Attachment J3

Submissions

Planning Submission
For: SP 67057: 23 Billyard Avenue, Elizabeth Bay

Development Application ('DA') No. 2023/0727
'Demolition of existing buildings, tree removal, excavation and construction of two new residential flat buildings, 6 to 8 storeys in height, with 22 apartments, 4 basement levels containing 27 car spaces, rooftop terraces, swimming pools and associated landscaping works including new tree plantings. The application is Integrated Development requiring the approval of Water NSW under the Water Management Act, 2000.'

Drawing title:
Sun Eye Views June 21st
11.00am-1.00pm Proposed

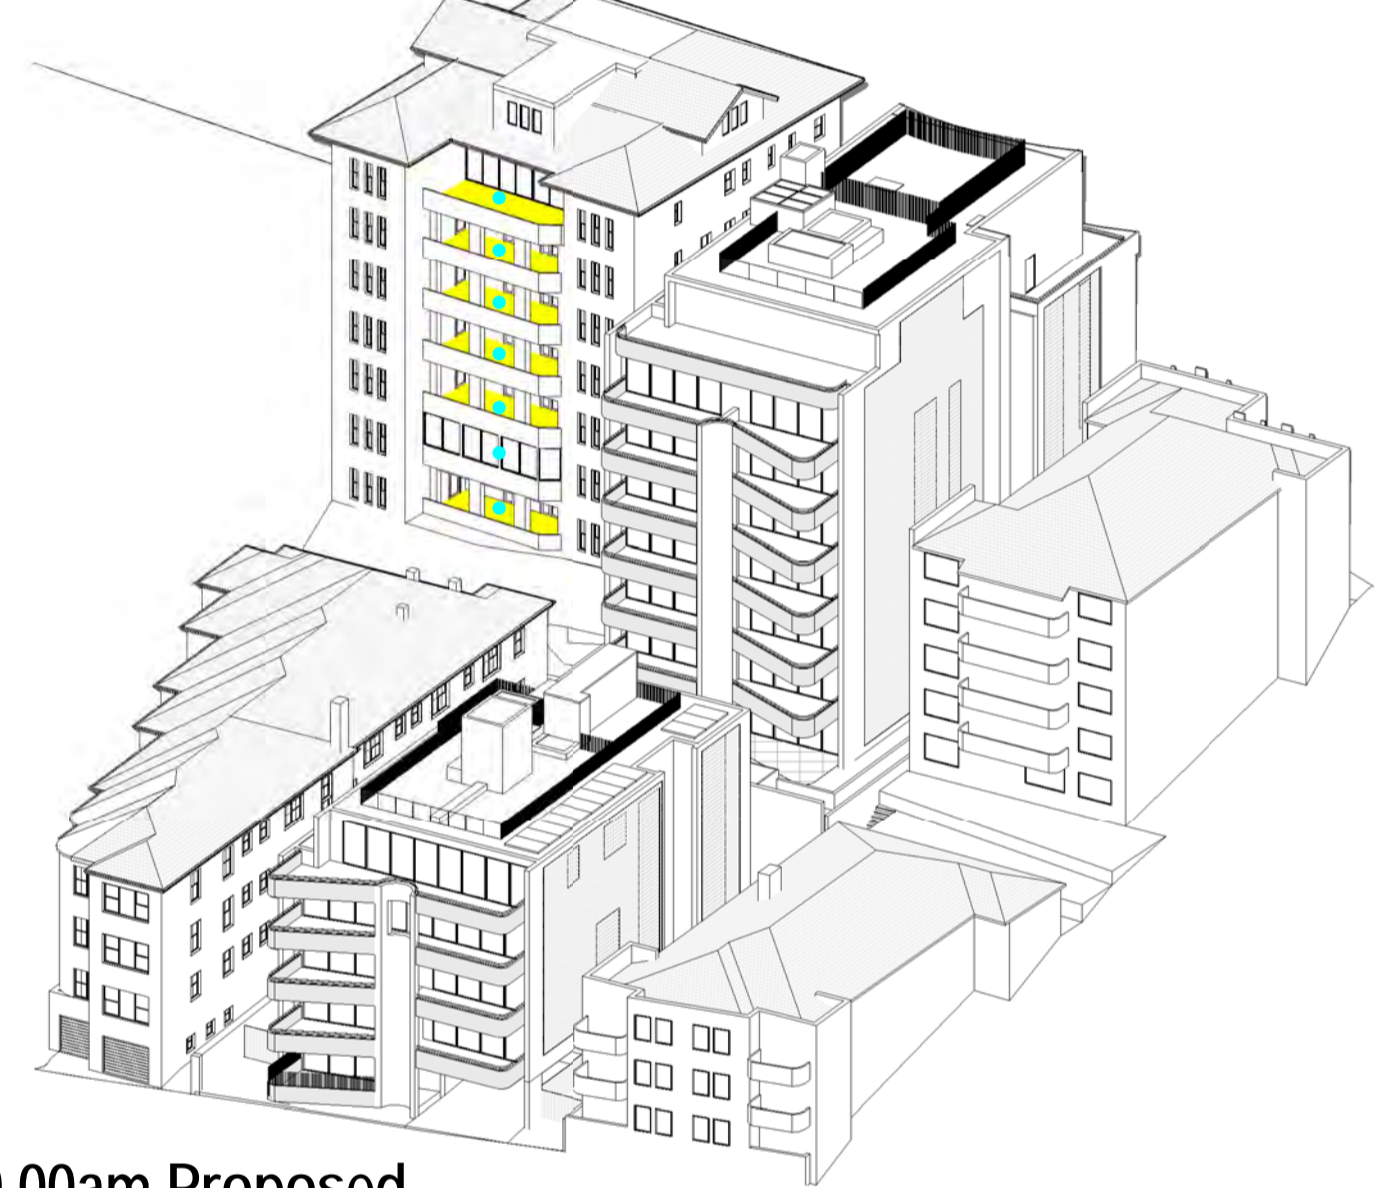
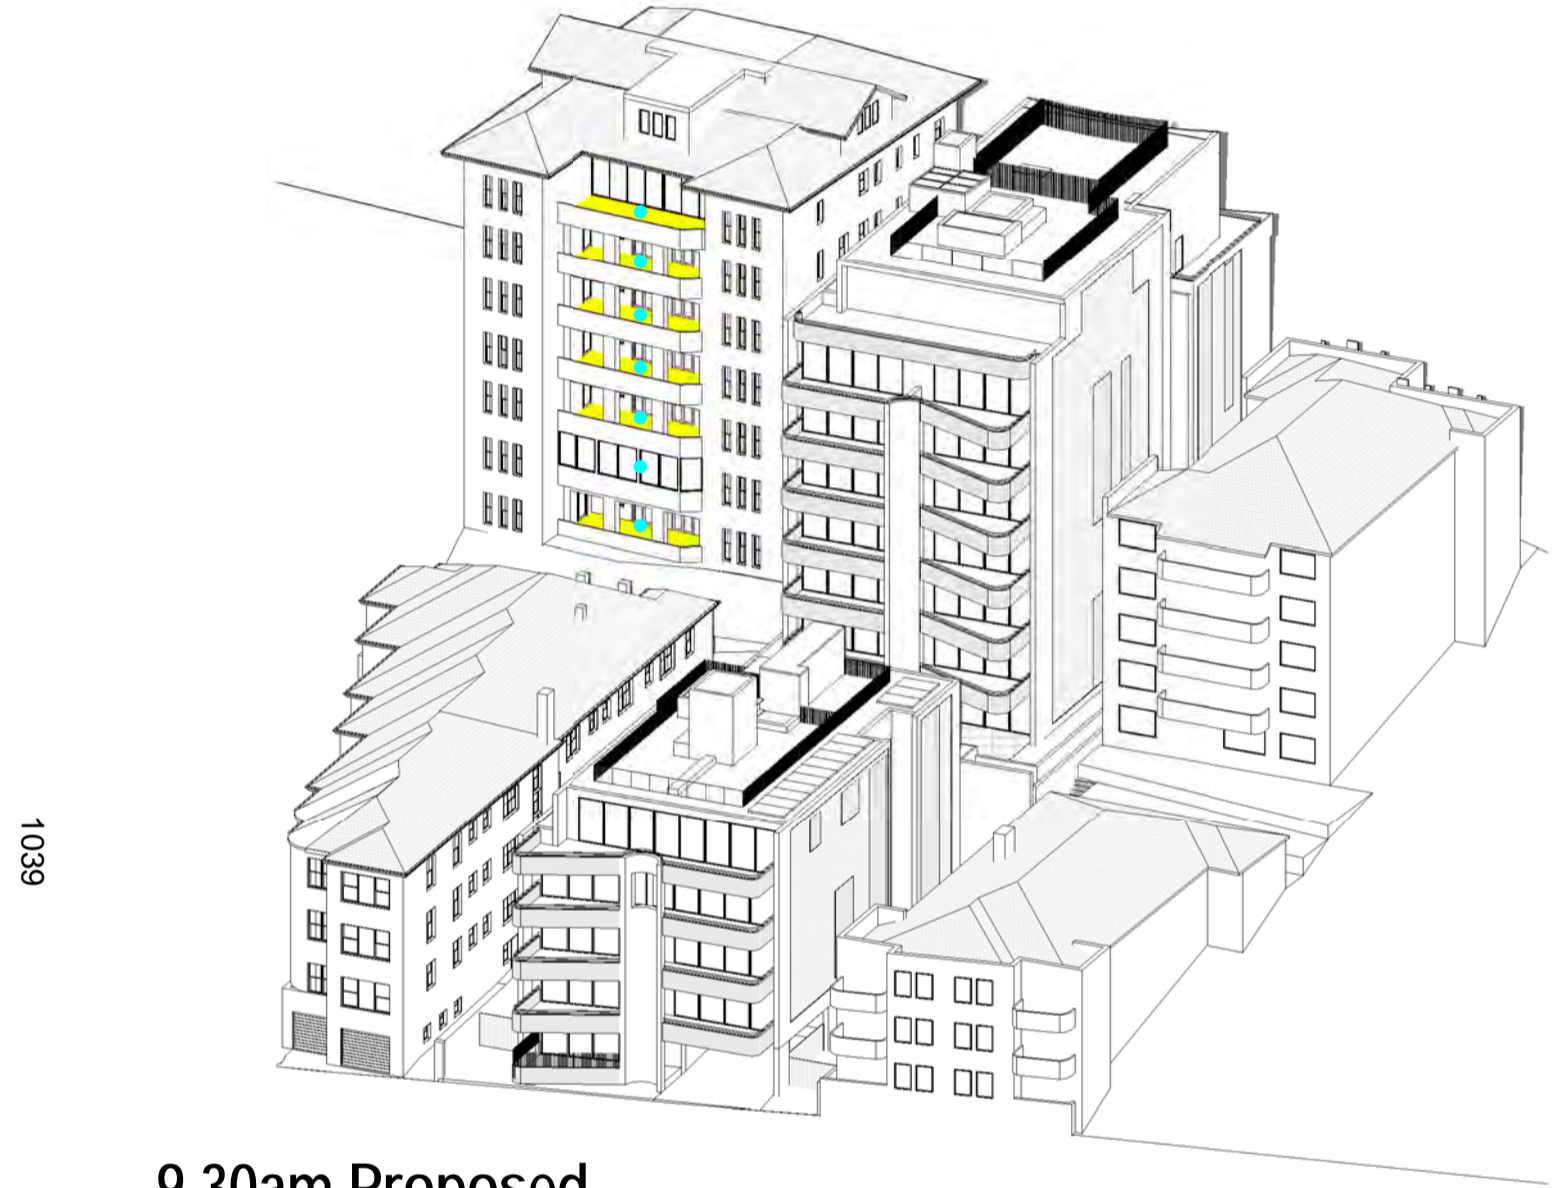
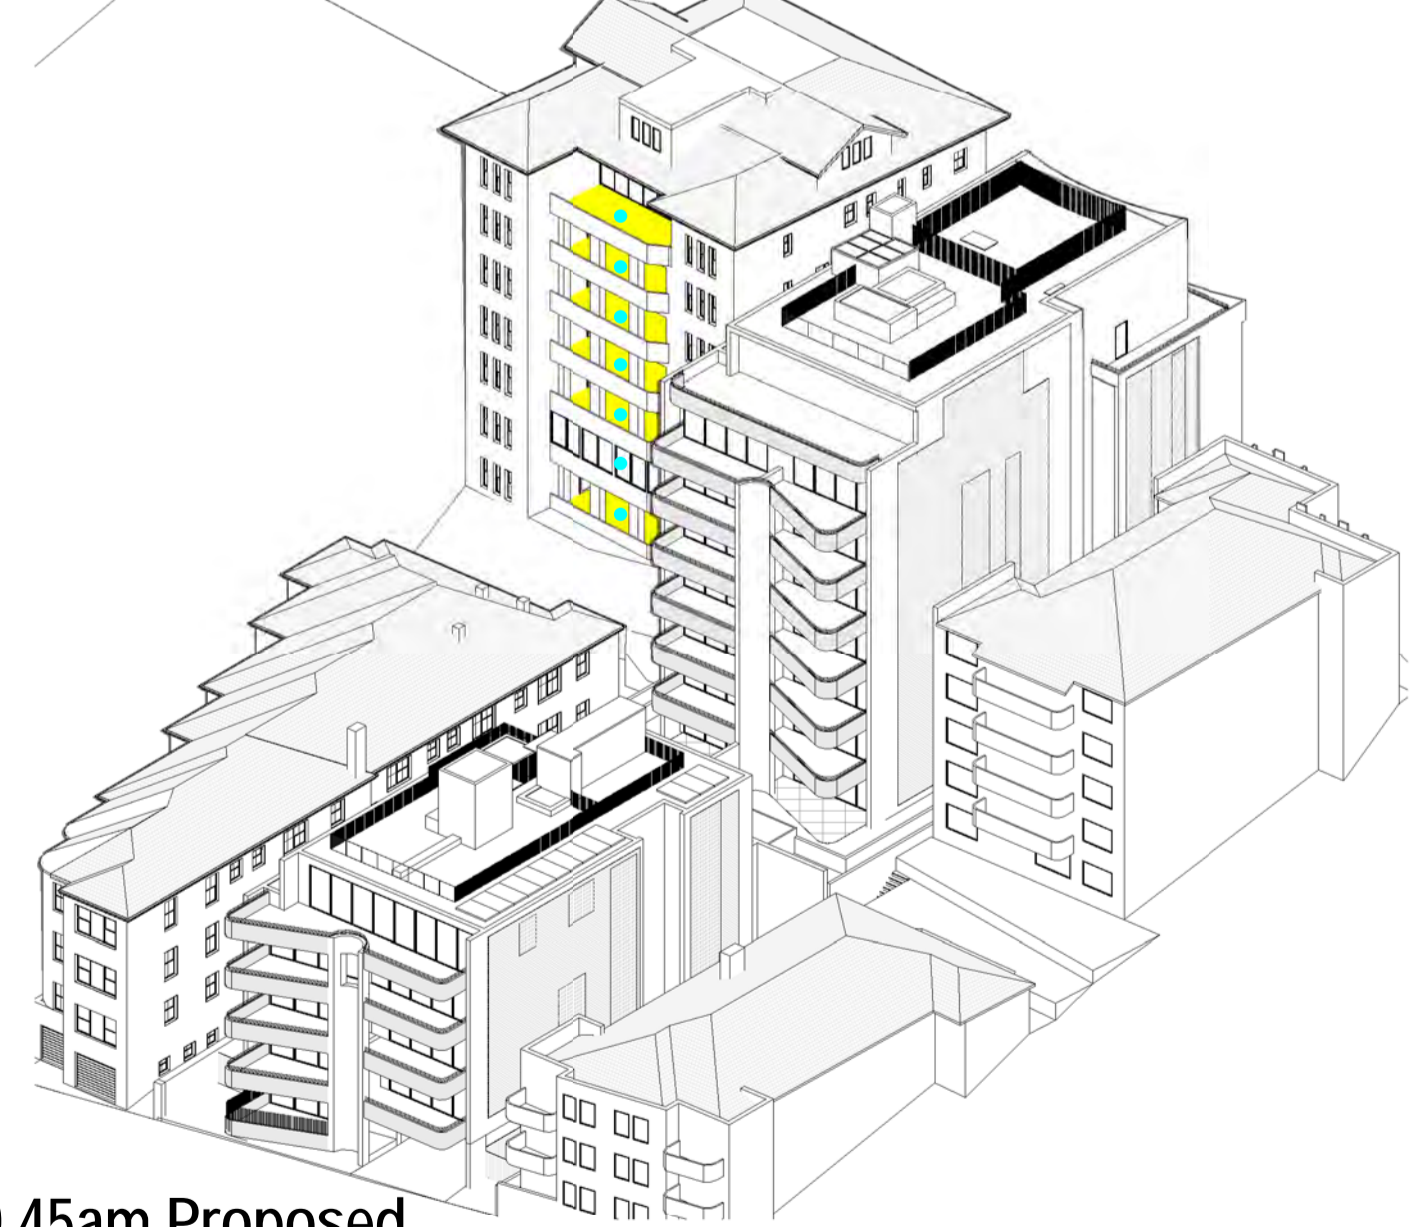
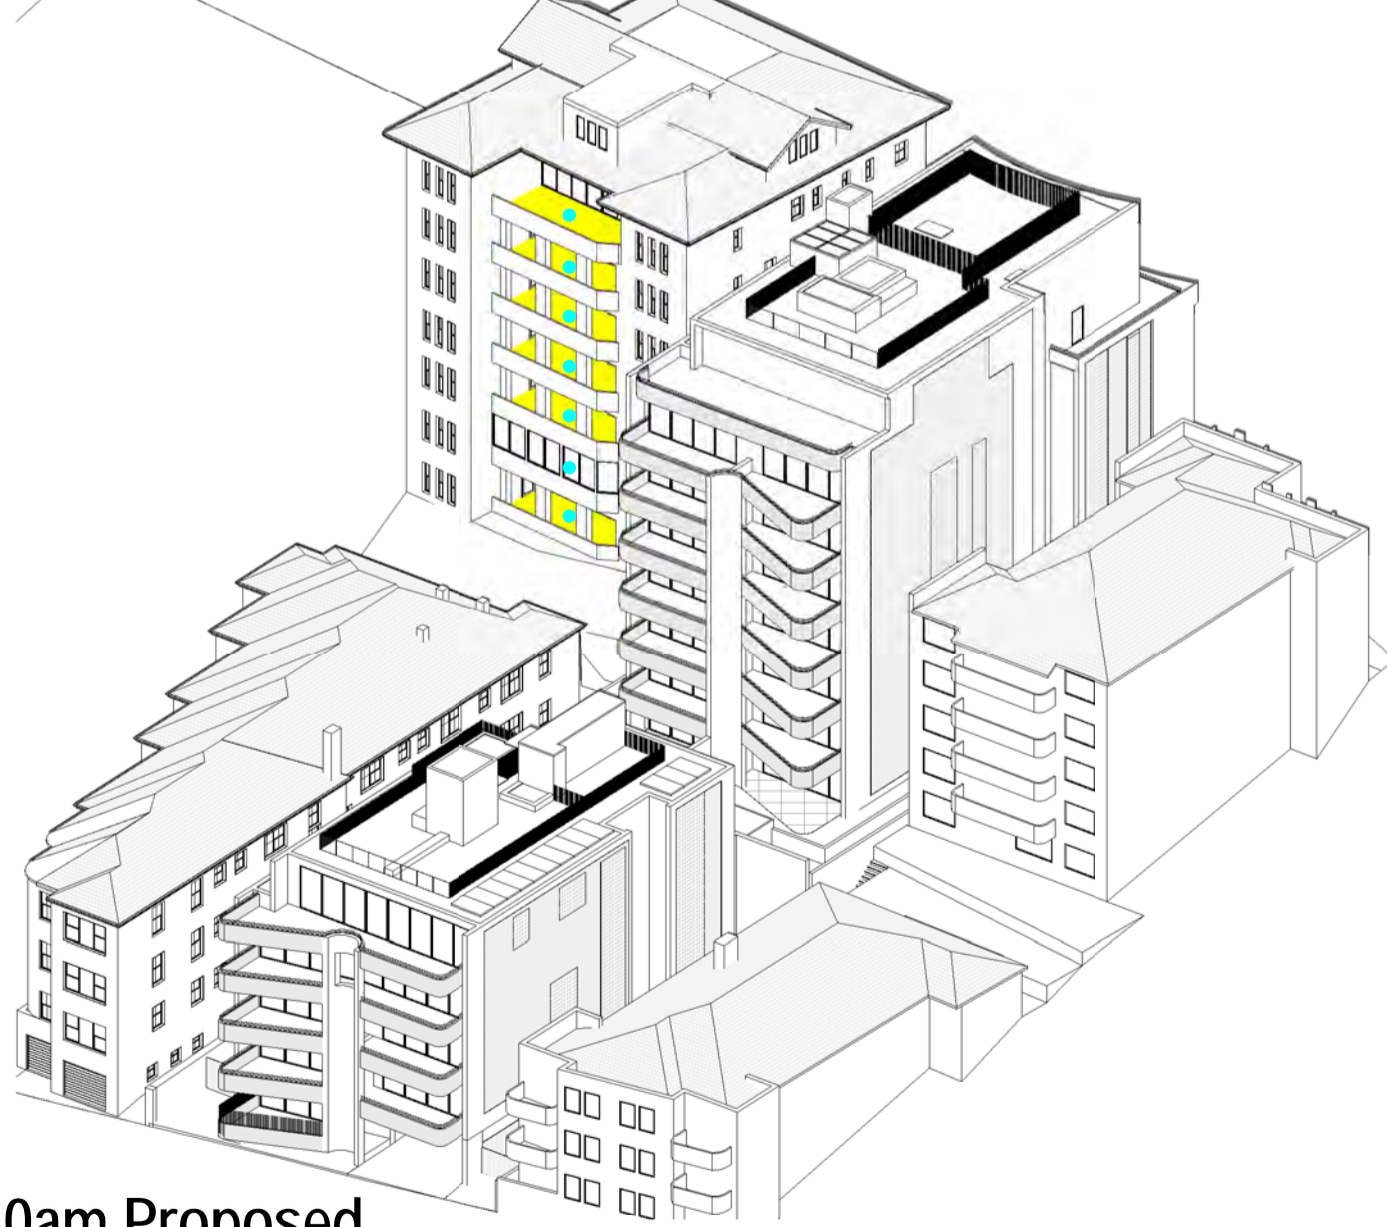
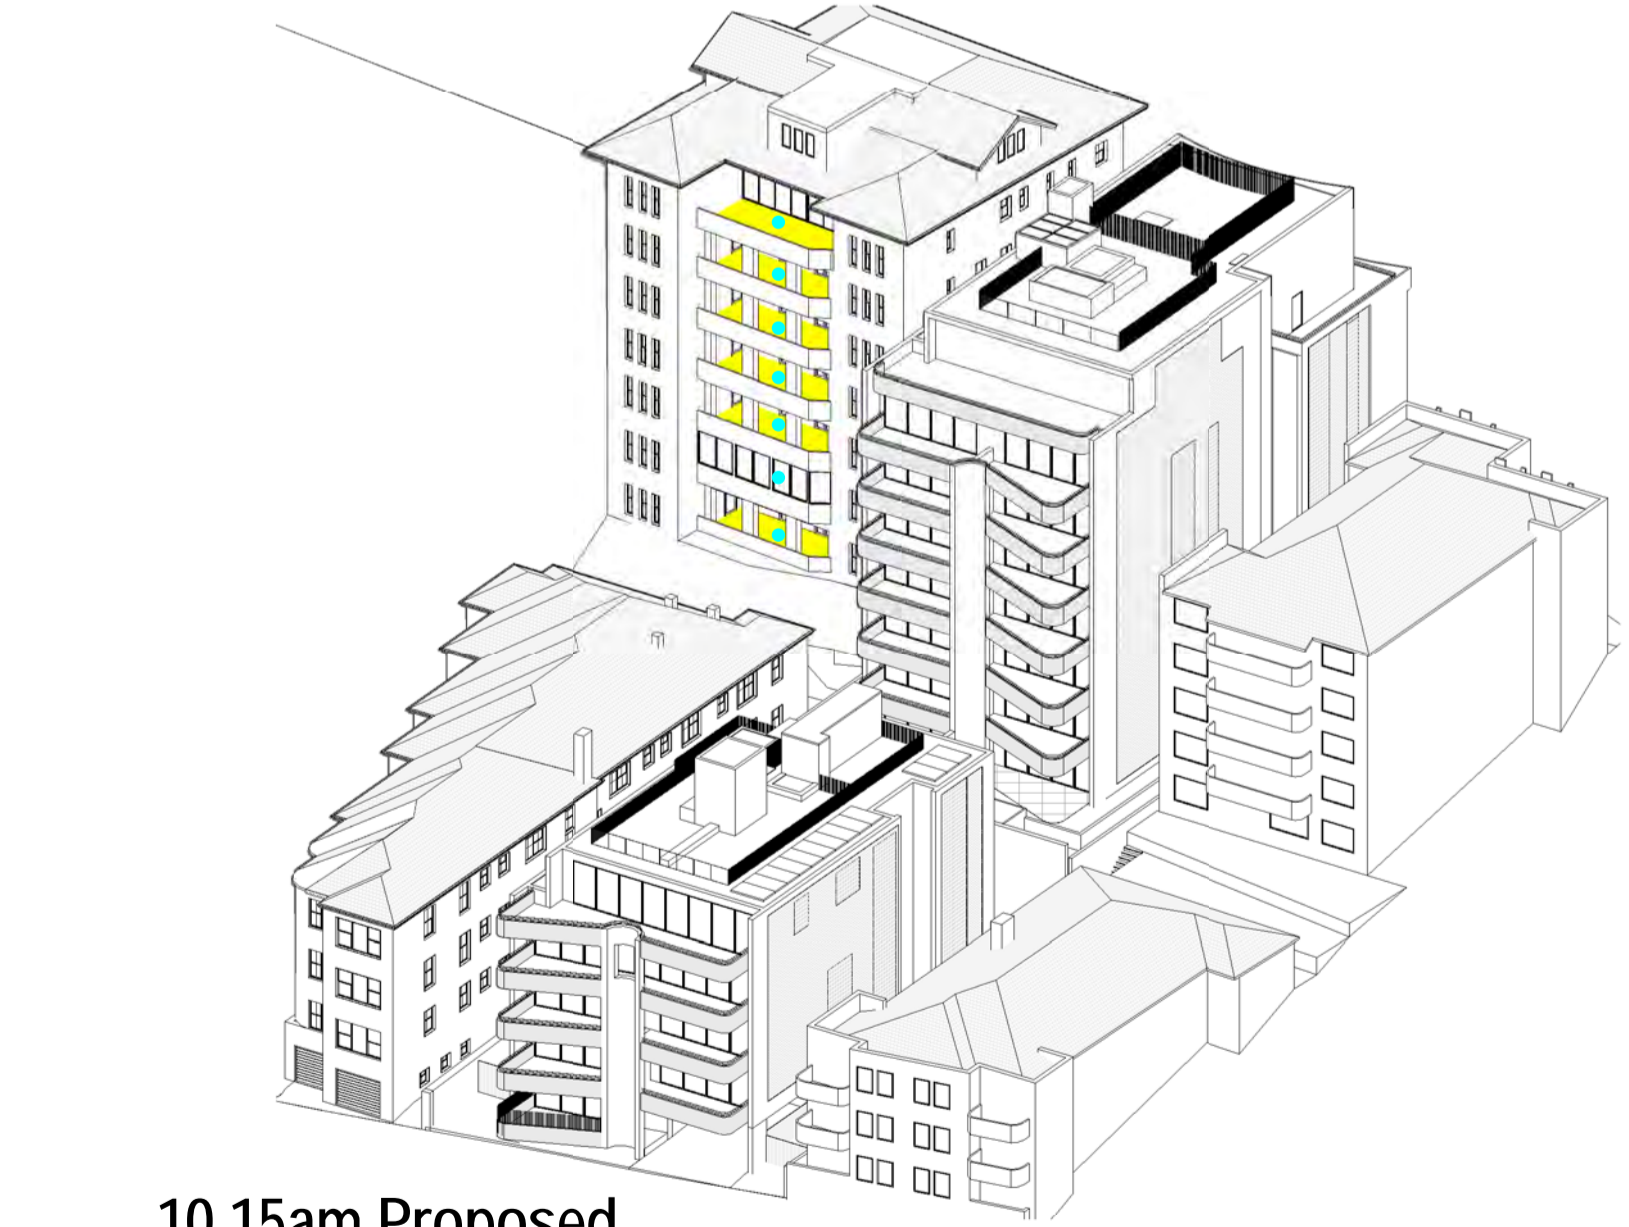
The solar diagrams show worsening of solar access to these only areas of living space (no balconies available). It is noted that staff requested 15 minute intervals and these have not been provided for 23 Billyard Avenue.

1.30	1.45	2.00	2.15	2.30	2.45	3.00	
UNIT 6 LIV	X	X	X	X	X	X	X	
UNIT 7 LIV	X	X	X	X	X	X	X	
UNIT 1 LIV	•	•	•	•	•	•	•	
UNIT 17 LIV	X	X	X	X	X	X	X	
UNIT 18 LIV	•	•	•	•	•	X	X	
UNIT 11 LIV	•	•	•	•	•	•	•	
UNIT 26 LIV	•	•	•	X	X	X	X	
UNIT 27 LIV	•	•	•	•	•	•	•	
UNIT 21 LIV	•	•	•	•	•	•	•	
TOTAL HOURS WINDOWS SOLAR ACCESS JUNE 21ST:								
9.00AM - 3.00PM								
	EXISTING:	PROPOSED:	ACCESS LOST:	% LOST:				
UNIT 6 LIV	0 HOURS	0 HOURS	0	0%				
UNIT 7 LIV	0.25 HOURS	0 HOURS	-0.25 HOURS	100%				
UNIT 1 LIV	6.0 HOURS	2.0 HOURS	-4.0 HOURS	66%				
UNIT 17 LIV	3.25 HOURS	2.25 HOURS	-1.0 HOUR	30%				
UNIT 18 LIV	1.5 HOURS	1.25 HOURS	-0.25 HOURS	16%				
UNIT 11 LIV	6.0 HOURS	2.0 HOURS	-4.0 HOURS	66%				
UNIT 26 LIV	4.25 HOURS	5 HOURS	+0.75 HOURS	+17%				
UNIT 27 LIV	6.0 HOURS	6.0 HOURS	0	0%				
UNIT 21 LIV	6.0 HOURS	3.5 HOURS	-2.5 HOURS	42%
